# Technical Service Bulletin

SUBJECT: <b>RATTLE OR TICKING NOISE FROM GLOVE BOX</b>		No: <b>TSB-12-52A-003</b>
		DATE: <b>November, 2012</b>
		MODEL: <b>2013 Outlander Sport/RVR</b>
CIRCULATE TO:	<input type="checkbox"/> GENERAL MANAGER	<input checked="" type="checkbox"/> PARTS MANAGER
<input checked="" type="checkbox"/> SERVICE ADVISOR	<input checked="" type="checkbox"/> SERVICE MANAGER	<input checked="" type="checkbox"/> TECHNICIAN
	<input type="checkbox"/> WARRANTY PROCESSOR	<input type="checkbox"/> SALES MANAGER

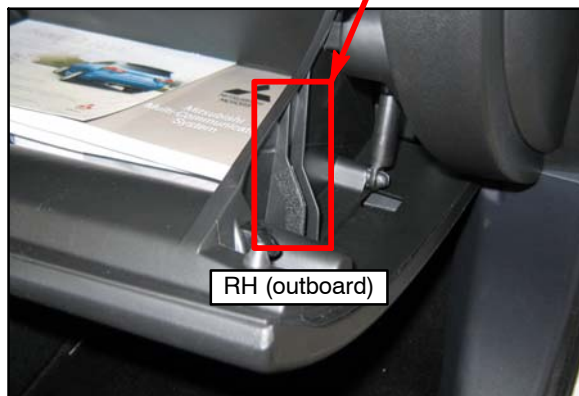
1. Remove existing felt strips from the indicated areas and discard them.

**NOTE:** These felt strips will not be replaced.

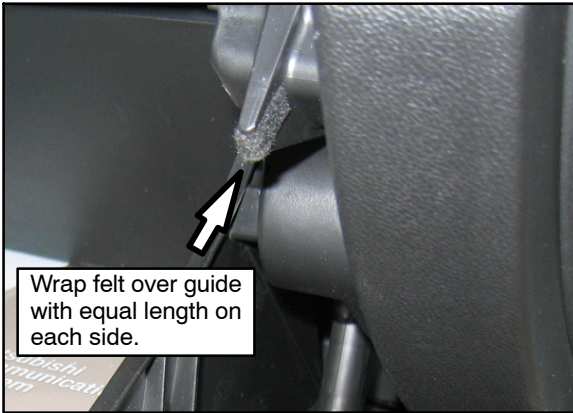
2. Cut a 6mm x 30mm felt strip from the 1mm thick sheet of non-woven felt provided in the Noise Suppression Service Kit (p/n MB991752). Place it over the guide at the RH side of the glove box opening as shown in the photo. Press the felt against the guide to ensure proper adhesion.
3. Test drive the vehicle on a rough road to confirm the noise is no longer present.
